SPRAB NOTE:

Site Plan
Atlantic Crossing
Florida
DeRay Beach

Drawing No.
SP-3
3 OF 7

SITE PLAN

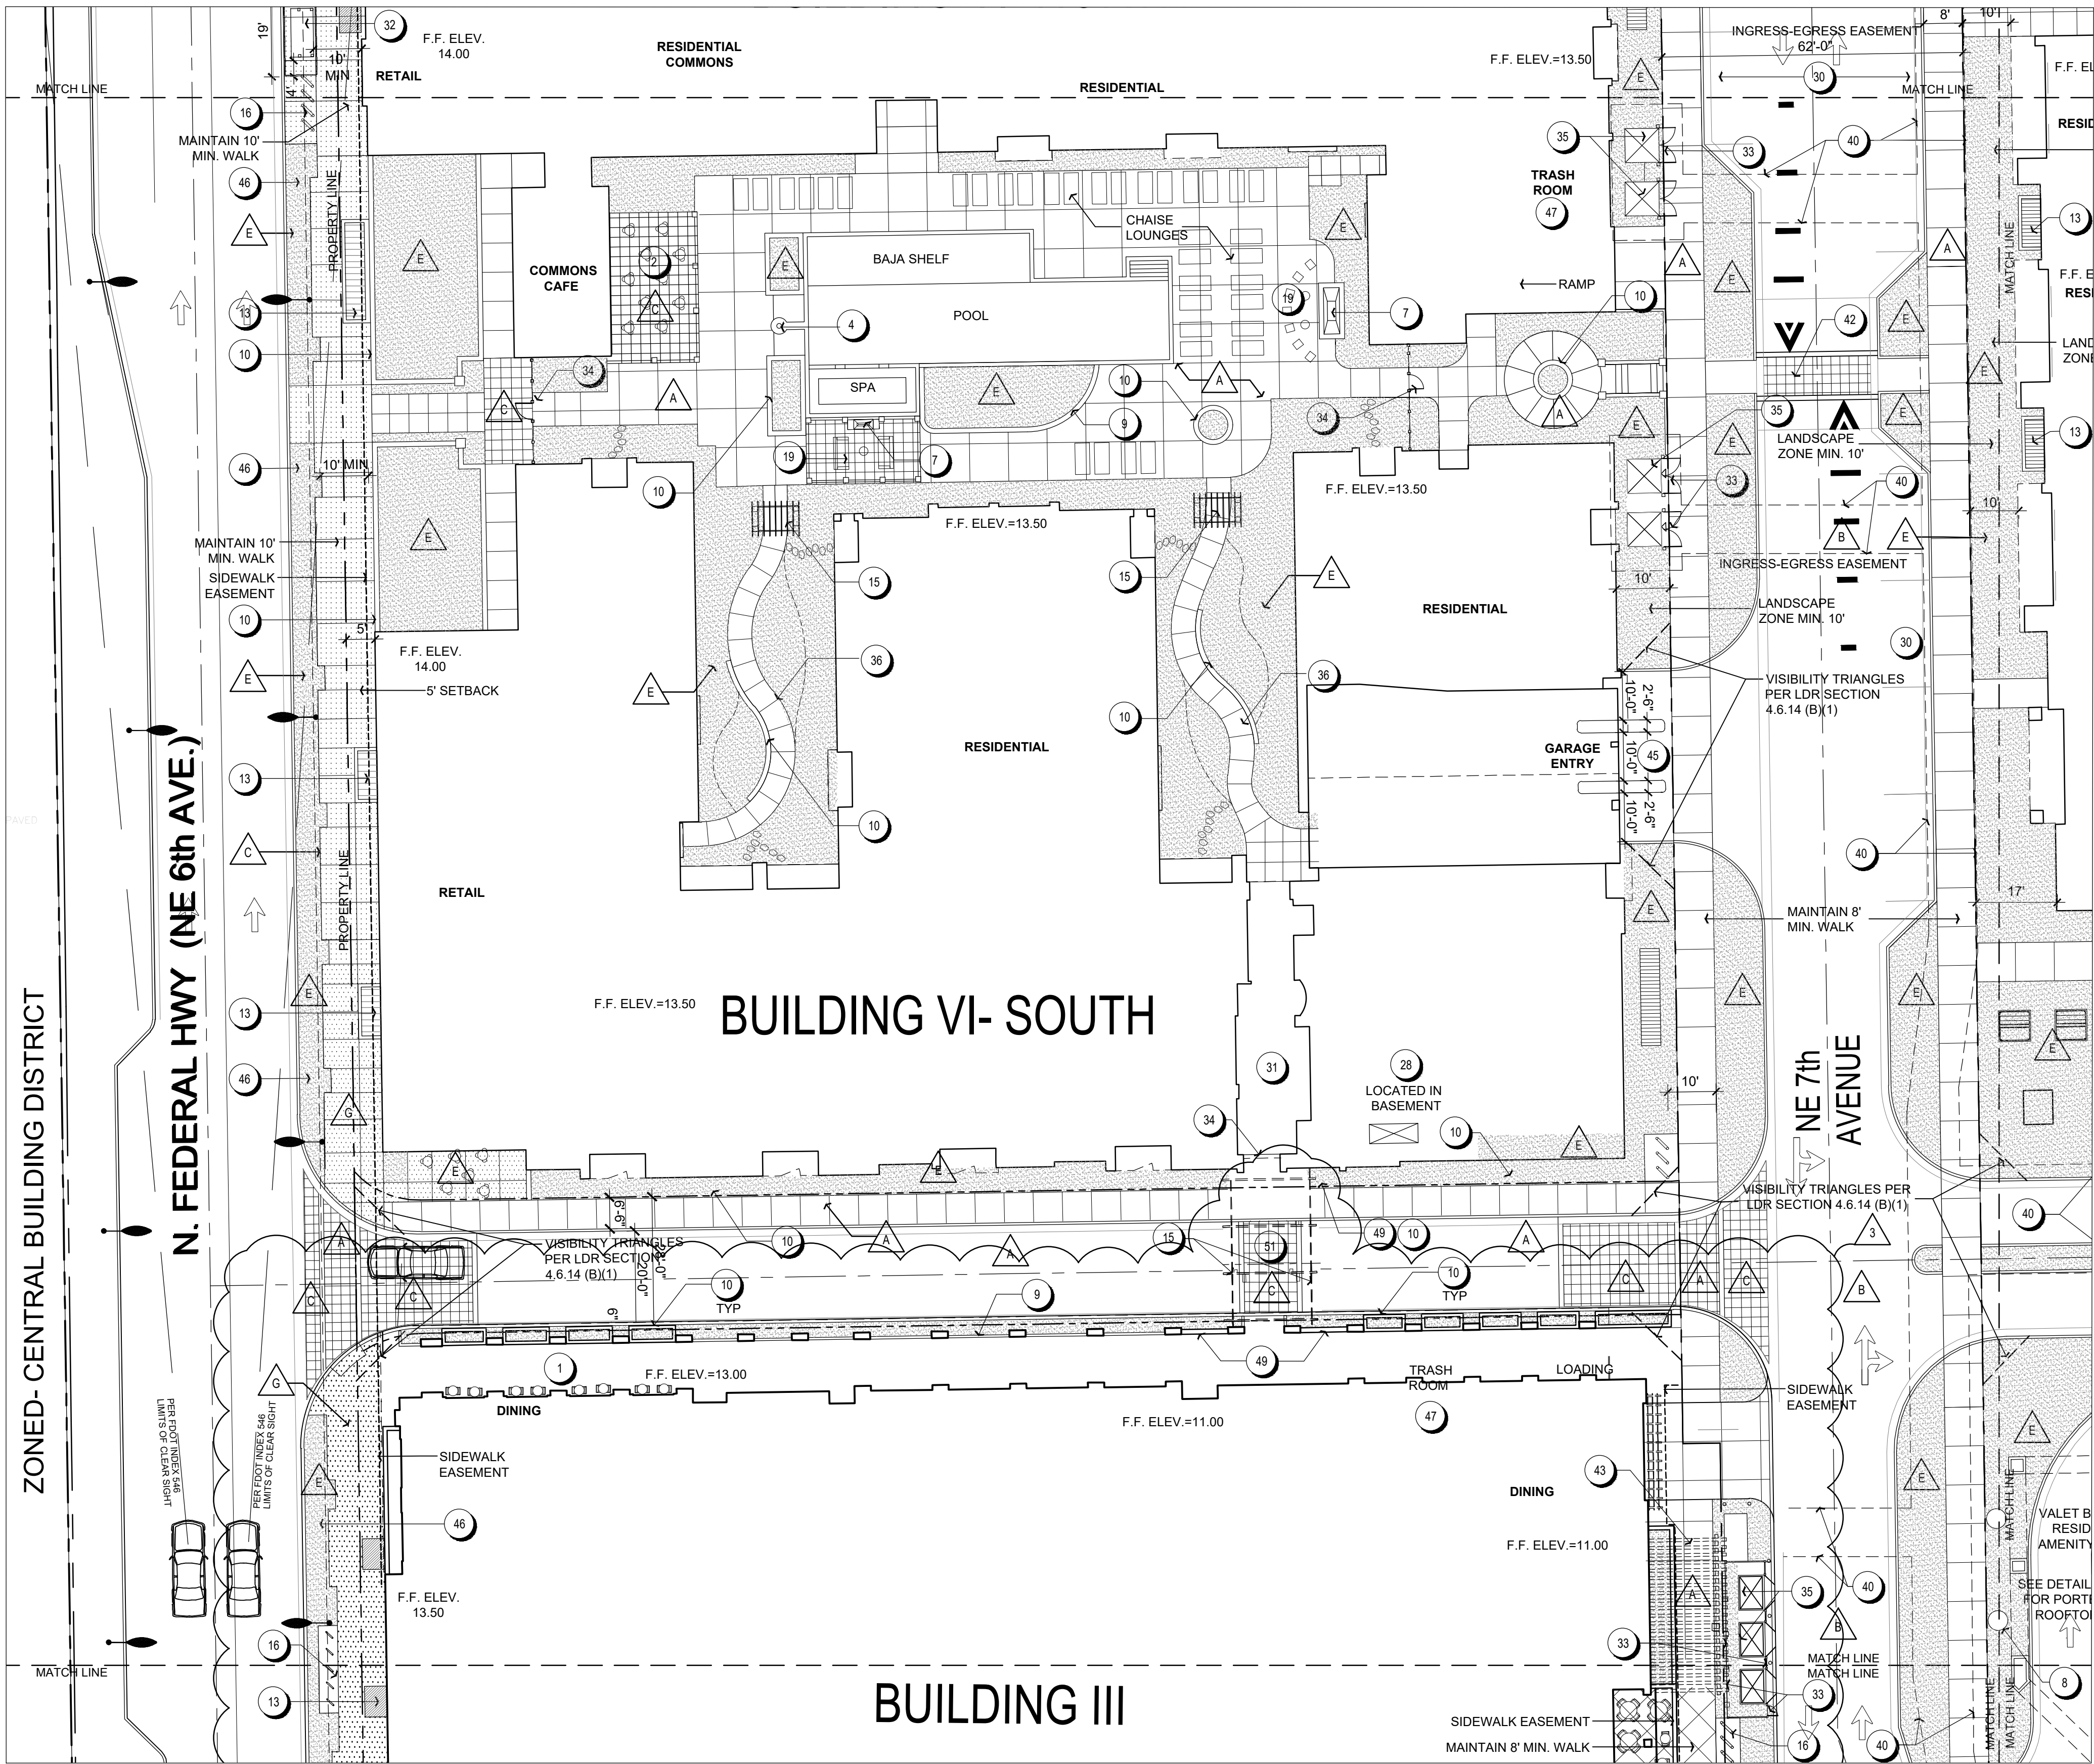
1. PLANTERS AND ORNAMENTAL WALLS ADDED ALONG ARCADE TO INCREASE SOIL DEPTH AND ADD VISUAL INTEREST.
2. OVERHEAD TRELLIS ADDED TO DEESIGNATE PEDESTRIAN CROSSING.
3. SCREEN FENCE AND GATES ADDED TO BETTER SCREEN HVAC EQUIPMENT.
